August 30, 2022

Re: Updates to Proposed Deacon Hayes Commons, Parsonage/Walnut Hill Roads

Deacon Hayes Commons  
North Yarmouth, Maine

## Hydrogeologic Assessment of an Engineered System Deacon Hayes Commons Walnut Hill Road, North Yarmouth

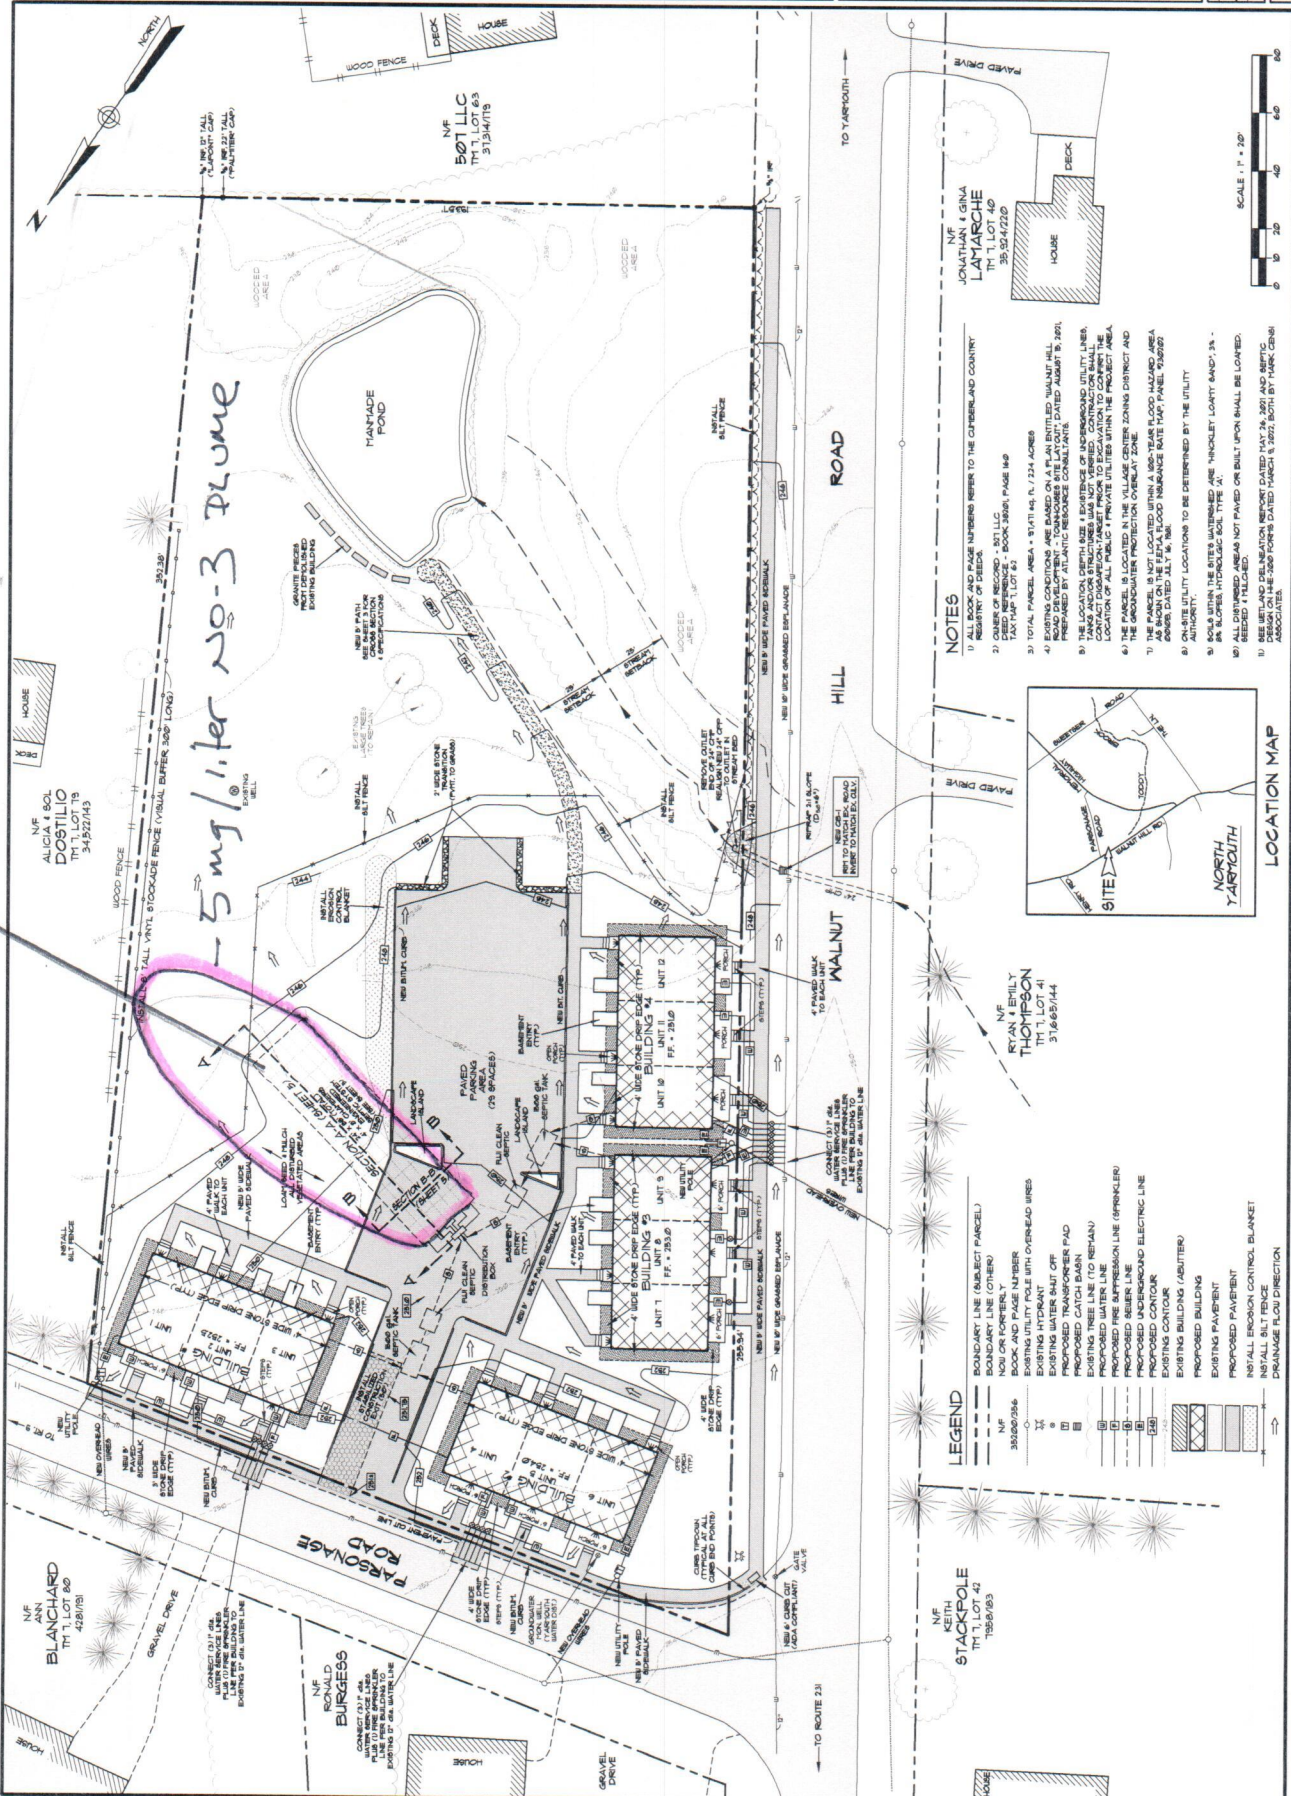
The groundwater flow direction assumption was changed to the regional assumption used by Drumlin Environmental, which is perpendicular to the topographic trend of Walnut Hill. On this property that direction is approximately True North, 98 degrees. A depiction of modelling results is attached.

Using the same modelling program used in the *Assessment*, with a reduced initial concentration of NO<sub>3</sub>-N based on nitrogen removal technology, the 5 mg/liter NO<sub>3</sub>-N plume is estimated to be 40 feet in length.

The disposal area will be approximately 45 feet from the nearest project property line, which will satisfy the North Yarmouth groundwater ordinance.

**SHEET SUB-1**

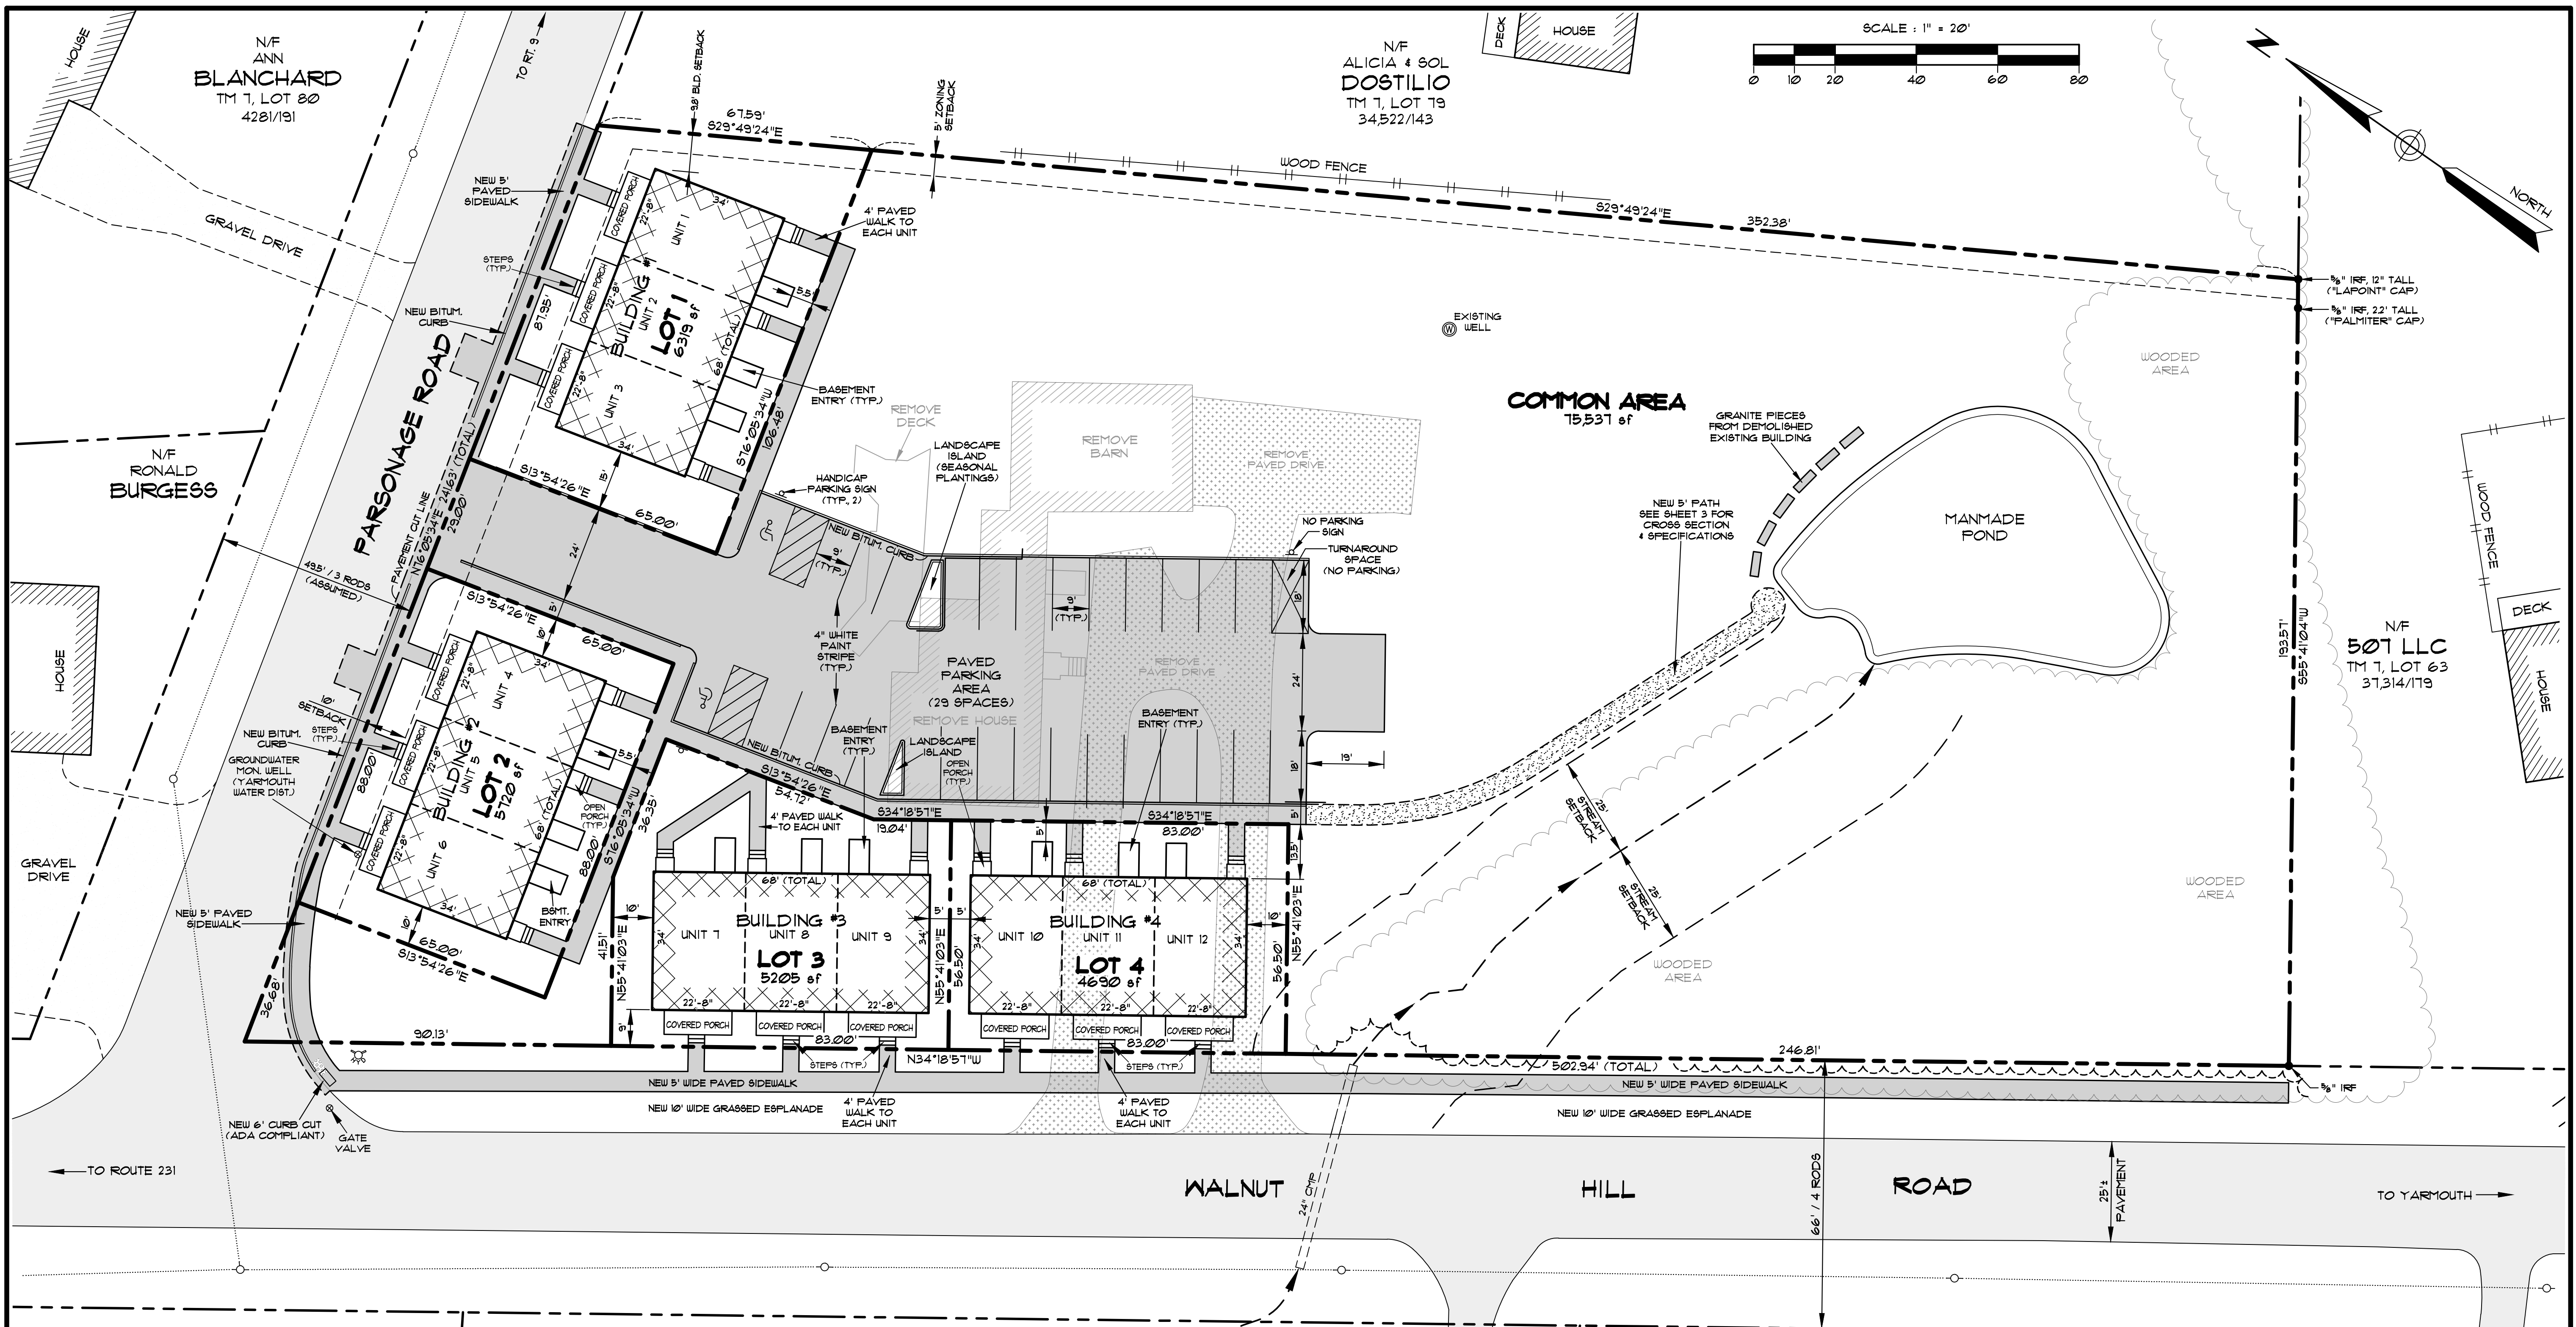
REV.	BY:	DATE:	CHANGES:
1	SJR	8-27-2022	RELOCATE WALNUT HILL ROAD SIDEWALK
2	SJR	1-22-2022	REMOVE PROPANE ADD BEARING DISTANCES RECORDING BLOCK
3	SJR	1-16-2022	RELOCATE LANDSCAPE AREA ADD STOCKADE FENCE
4	SJR	6-28-2022	RELOCATE TREES ADD SNOW STORAGE 4 UNIT NUMBERS
5	SJR	6-24-2022	ADD LOTS, ADD LOT AREA TABLE, EXTEND SIDEWALK
6	SJR	6-18-2022	ADD PARCEL TO BE CONVERTED TO 507 LLC
7	SJR	5-27-2022	REDO BUILDING 9 ZONES, ADD FENCE, LANDSCAPE CHANGES

**GRADING & EROSION CONTROL PLAN**  
**DEACON HAYES COMMONS**  
 527 WALNUT HILL ROAD - NORTH YARMOUTH MAINE  
 PREPARED FOR  
**527 LLC**  
 865 OAK HILL ROAD - NORTH YARMOUTH, ME

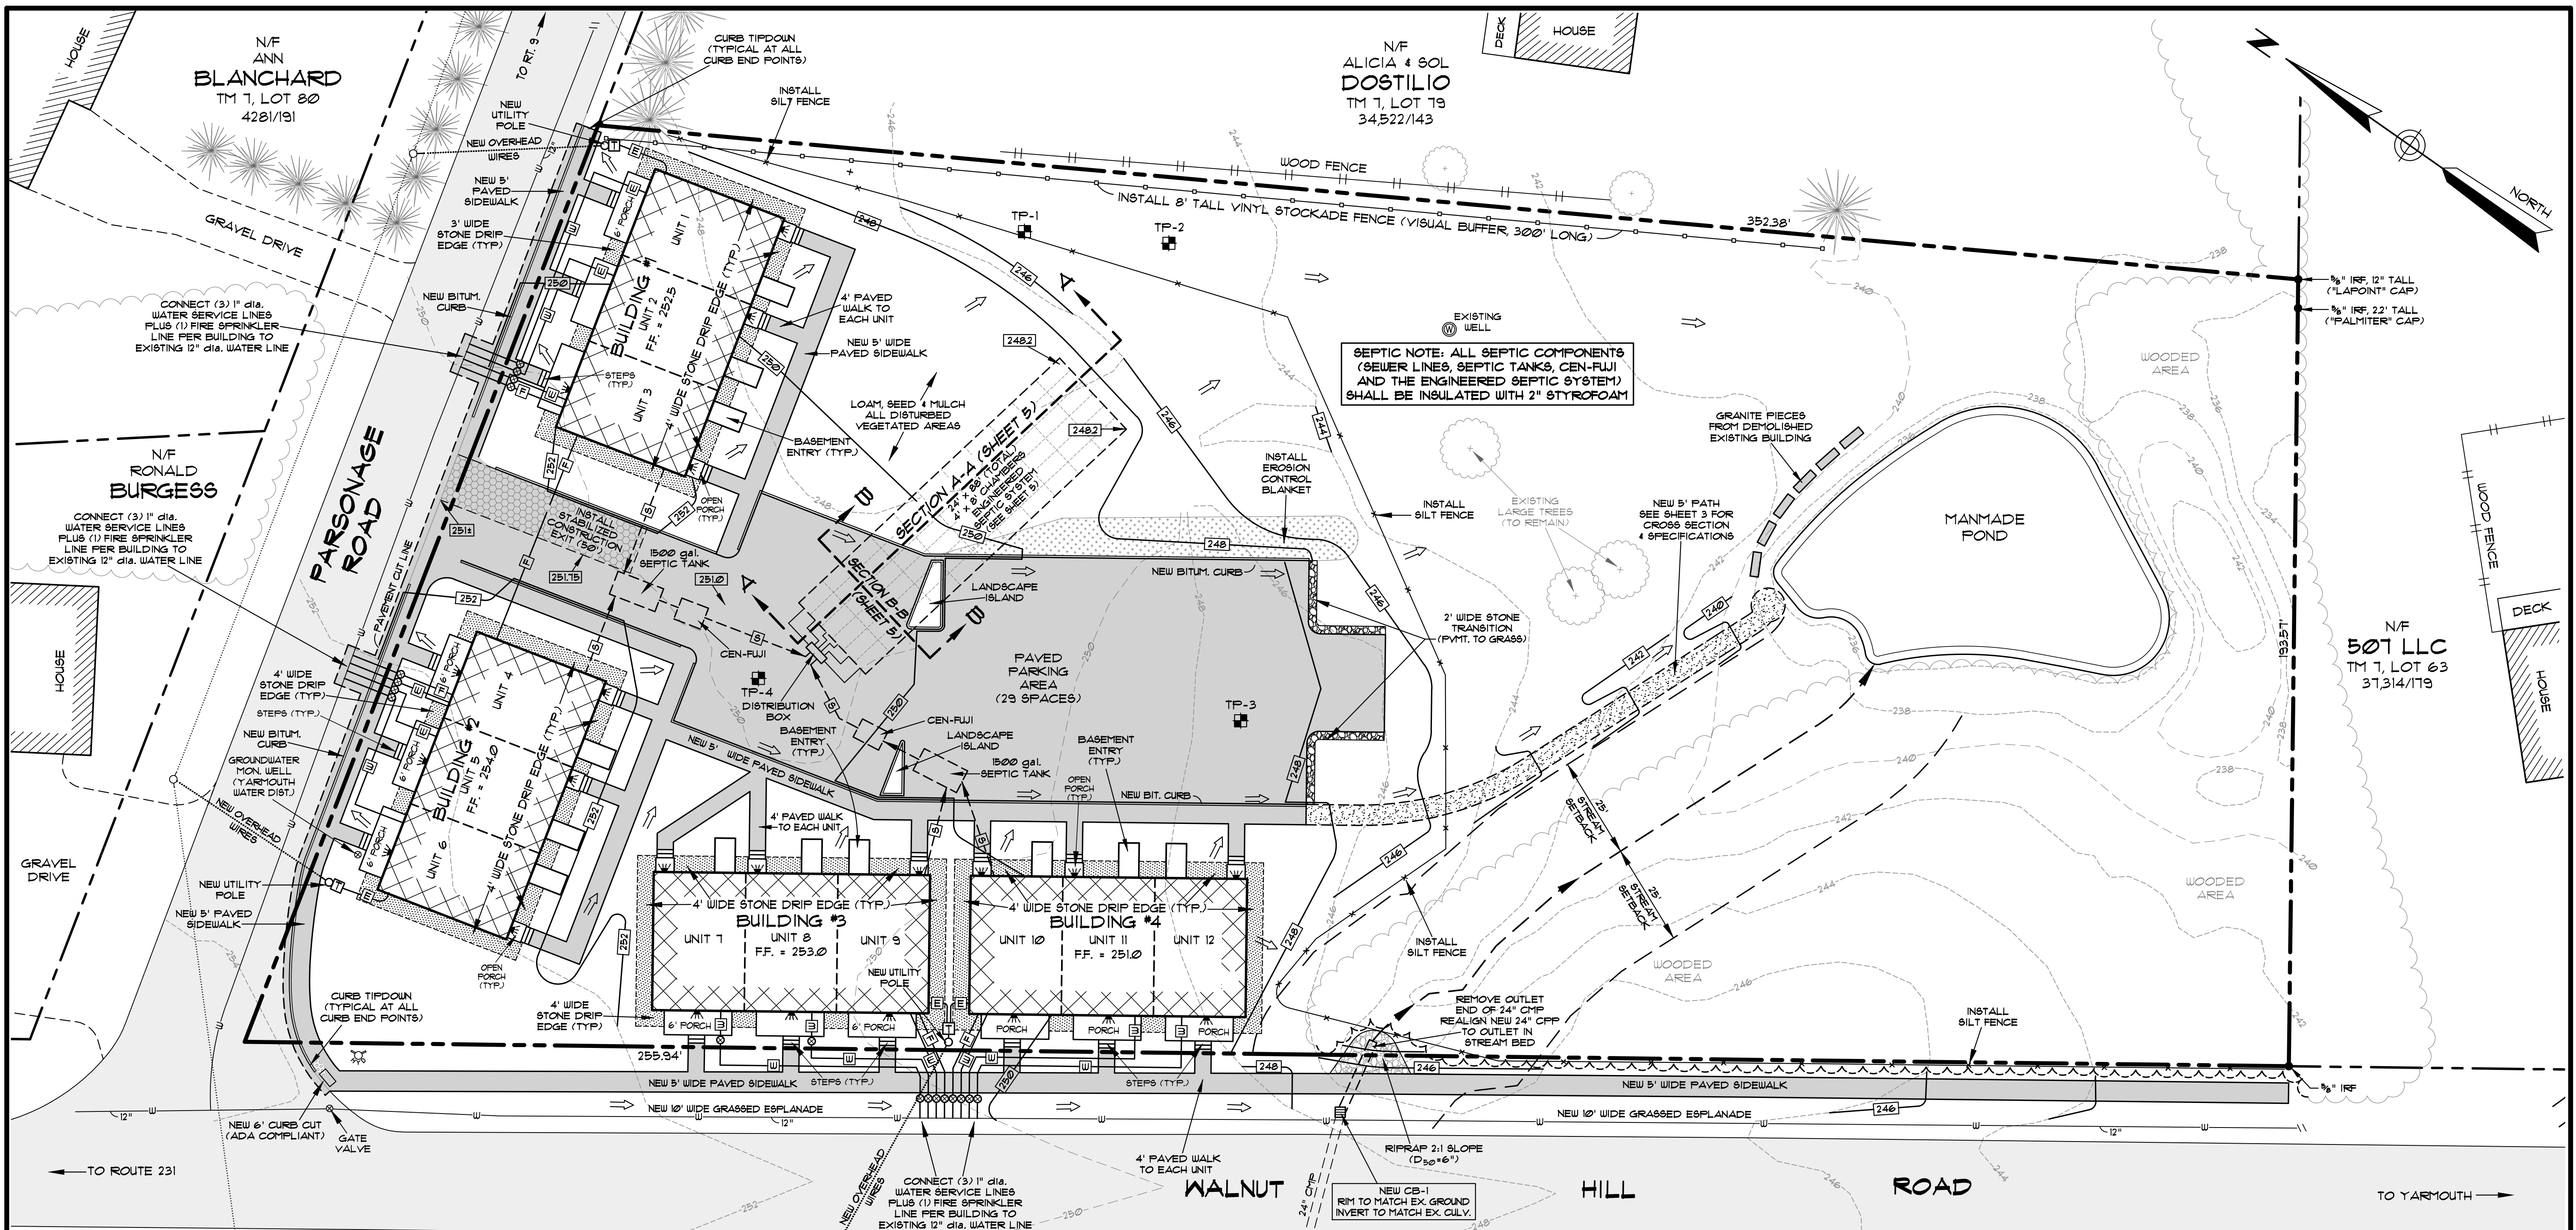
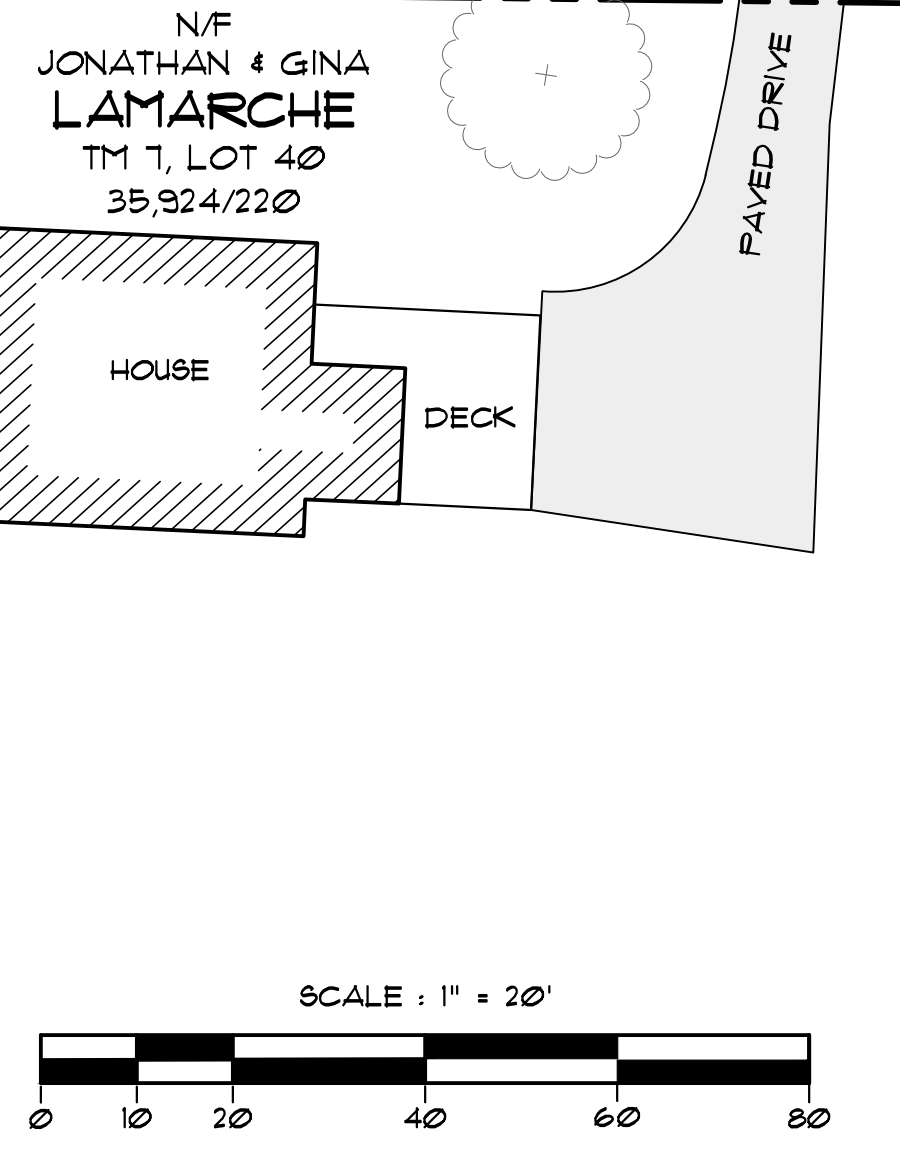
REV.	DATE	BY	DESCRIPTION
1	8-27-2022	SJR	RELOCATE WALNUT HILL RD. SIDEWALK, NEW SEPTIC
2	1-22-2022	SJR	RELOCATE PROpane TANKS, ADD STOCKADE FENCE
3	1-16-2022	SJR	RELOCATE PROpane TANKS, ADD STOCKADE FENCE
4	6-28-2022	SJR	LABEL UNITS, WATERLINE SERVICE REVISIONS
5	6-24-2022	SJR	EXTEND SIDEWALK, RELOCATE WATER LINES
6	6-18-2022	SJR	ADD PARCEL TO BE CONVERTED TO 507 LLC
7	5-27-2022	SJR	RECONFIGURE BUILDING SIZES

**SEPTIC NOTE:** ALL SEPTIC COMPONENTS (SEWER LINES, SEPTIC TANKS, CEN-FLUI AND THE ENGINEERED SEPTIC SYSTEM) SHALL BE INSULATED WITH 2" STYROFOAM
